VYSVĚTLENÍ ZADÁVACÍ DOKUMENTACE POŘ. Č. 17

EXPLANATION OF THE TENDER DOCUMENTATION No. 17

Zadavatel: / **ŠKO-ENERGO, s.r.o.**
Contracting Entity: tř. Václava Klementa 869, Mladá Boleslav II, 293 01 Mladá Boleslav,
IČO: / Identification No.: 61675938

Název: / Name: **„Modernizace teplárny ŠKO-ENERGO – OB2 Kotelny“**

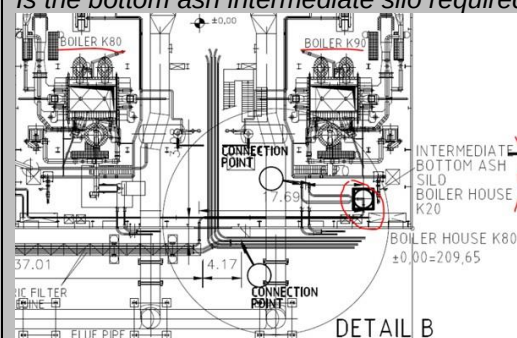
List of preferred vendors	Is this list mandatory? [pozn. zadavatele: název dodavatele byl začerněn] will try to follow this list, but we have succesful experience with other vendors. Price will also influence the selection of supplier.
---------------------------	---

Povinnými je pouze dodavatel kompresoru stlačeného řídicího vzduchu a ochran vysokého napětí, a to z důvodu technické kompatibility. Tito dodavatelé jsou uvedeni v první tabulce z přílohy A 10 zadávací dokumentace – Vendor list. V ostatních případech se jedná pouze o doporučení na základě aktuálního stavu.

Only the supplier of the compressed control air compressor and the high voltage protection are required, due to technical compatibility. These suppliers are listed in the first table of Annex A 10 to the Tender Documentation – Vendor list. In other cases, it is only a recommendation based on the current state.

01 80HFB10AF001

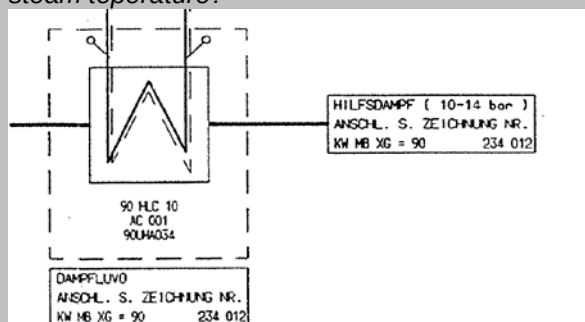
Is the feeder shown in document "01 80HFB10AF001 Dokumentační list - Vynášecí dopravník uhlí 1-Výkres, Kusovník" is a feeder feeding the existing coal silo? According to the table the feeder has a capacity of 1.9-19 t/h

Jedná se o šikmý řetězový vynášecí dopravník pod uhelným bunkrem.

It is an slanting chain conveyor under a coal bunker.

05 90H234011-07 RI
schema Verbrennungsluft
Teil 1 - Spalovací vzduch
část 1.pdf

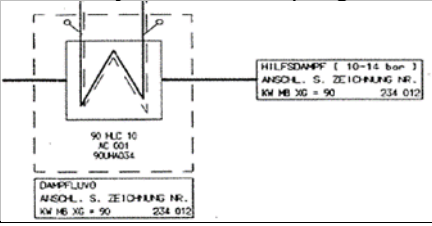
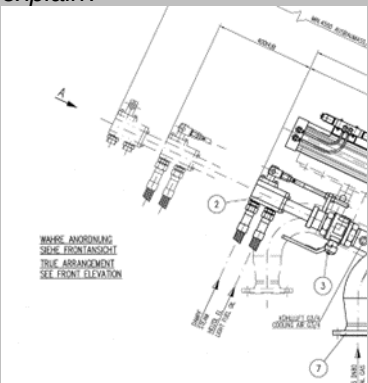
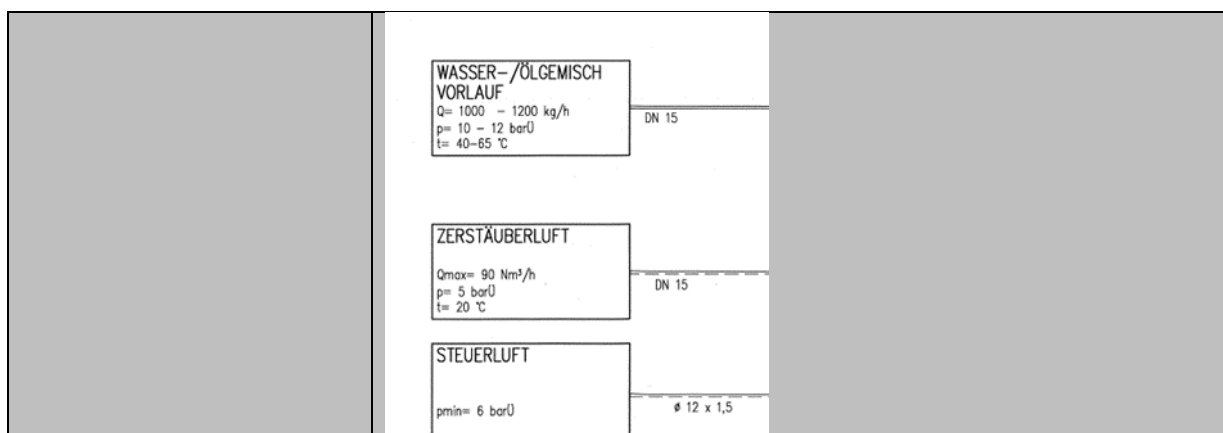
Could you confirm that auxiliary steam is available on site? If so, in what location? Could you confirm steam parameters 10-14 bar(g)? What is steam temperature?

Parametry pomocné páry jsou 14 bar, 250 °C. Přívod páry se nachází na kótě +21,4 m k parnímu ohříváku vzduchu, odbočka je vedena i na kótu 0 m ke spodní části výparníku, která se používá pro předehřev při najíždění. Rozvody pomocné páry jsou na více místech kotelny, část toho může být zřejmá z poskytnutého 3D modelu.

The auxiliary steam parameters are 14 bar, 250 °C. The steam pipeline is located at +21.4 m to the steam air heater, this pipeline is also led to 0 m to the lower part of the evaporator, which is used for preheating during start-up. The auxiliary steam distributions are in several places of the boiler hall, this can be visible from the 3D model.
